The New Service Bulletin **Look!!!** All Future Product Service Bulletins Will Be On White Paper . . . Easier To Read . . . Clearer Photographs and Illustrations. . . Product Identification At TOP of Bulletin For Easy Filing.

- A. Battery Installation/Outboard Powered Aluminum Boats
- B. Quicksilver Tachometer/RPM Indicator
- C. Bearing Carrier Lube Fittings - New 80/90/ 115 HP Models
- D. Engine Installaiton - New 50/70 HP Models

Figure 2. Tool Modification

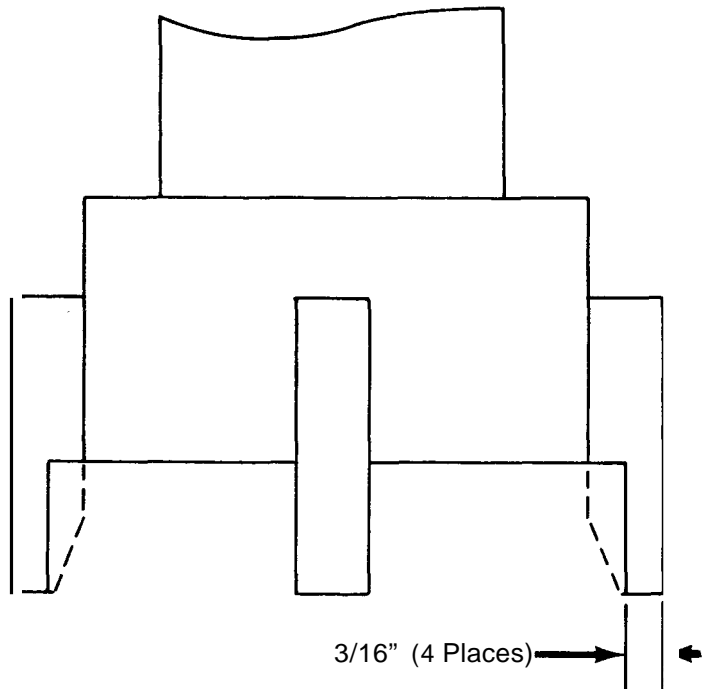
The older Gear Housing Cover Tool P/N 91-73688 will strike on the outer lubrication fitting. The tool must be modified by machining the inside diameter, as shown in Figure 2 (or, a new, modified tool, 91-73688 may be purchased).

Figure 3. Installing Engine on Transom

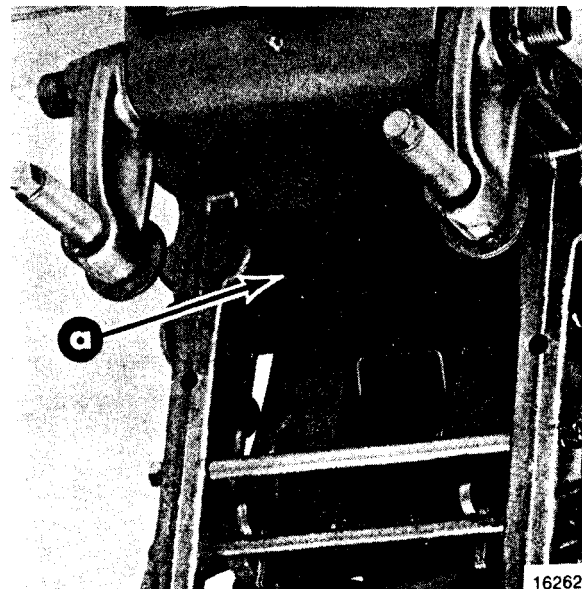
The shock absorbers are no longer standard equipment on new 50/70 HP models. They have been replaced with a nylon strap. When installing these outboards on the boat transom. **MAKE CERTAIN** that the nylon strap is not caught between engine and top of boat transom. (Figure 3)

NOTE: Power Trim Installation Kit, P/N 62538A3 now contains the installation pins that were previously standard when the shock absorbers were on the outboard.
